Part No: D206-642-241

Part Name: Replacement Skidtube, High Gear with Standard Wearplates Fits LH or RH

DRAWING NO. D2650	TITLE 206/407 SKIDTUBE ASSEMBLIES	REV. F	DART AEROSPACE LTD ENGINEERING ORDER		D.E.O. NO. D2650-F-1	SHEET NO. SHEET 1 OF 1	SCALE NTS
DRAWN <i>UP</i>	CHECKED <i>A.P.</i>	MFG. APPR. <i>AA</i>	APPROVED <i>#</i>		DE APPR. <i>#</i>		
DATE 12.10.12	DATE 12.10.22	DATE 12.10.22	DATE 12.10.22		DATE 12.10.22

CHANGE C'BORED WELDED CROSSBOLT SPACERS TO SWAGED SPACERS

DETAIL B

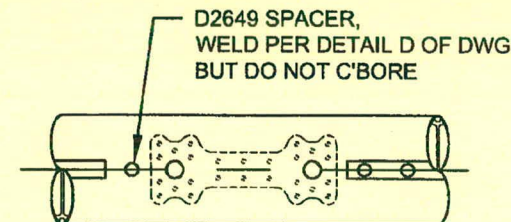
ADD DETAIL G BELOW, WHICH IS THE SAME SECTION VIEW AS DETAIL D OF DWG.

C'BORED HOLES ARE **NOW SWAGED** PER DETAIL G BELOW. FOR THE Ø0.375 HOLE THAT IS NOT C'BORED, WELD PER DETAIL D OF DWG (SEE AMENDED DETAIL B FOR REFERENCE).

AMENDMENT TO DETAIL B
NOT TO SCALE

DETAIL G

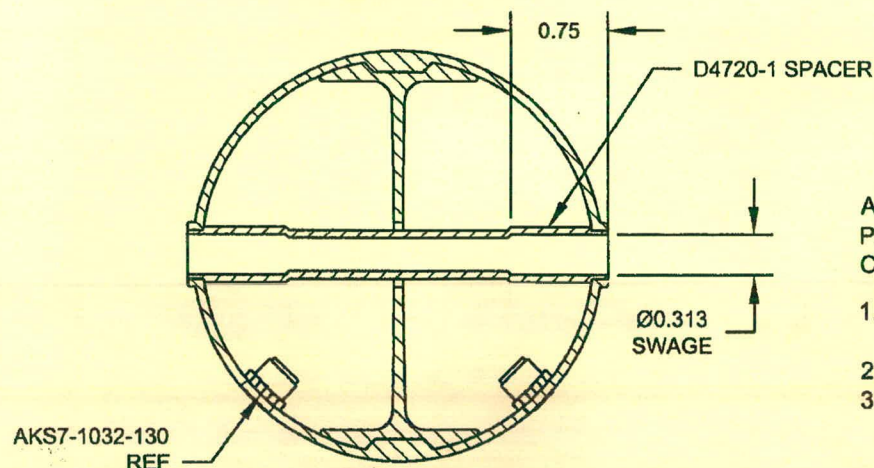
FOR Ø0.375 HOLES ONLY
FOR HOLES THAT ARE CURRENTLY C'BORED ONLY
NOT TO SCALE

AFTER DRILLING AND BENDING ASSEMBLY
PERFORM THE FOLLOWING FOR Ø0.375 HOLES THAT ARE
CURRENTLY C'BORED:

1. INSERT D4720-1 SPACER, 16 PL (-1) OR 17 PL (-3)
OR 19 PL (-5) OR 23 PL (-7)
2. SWAGE TO Ø0.313 X 0.75 DP PER QSI 002
3. TRIM / GRIND FLUSH PER QSI 002
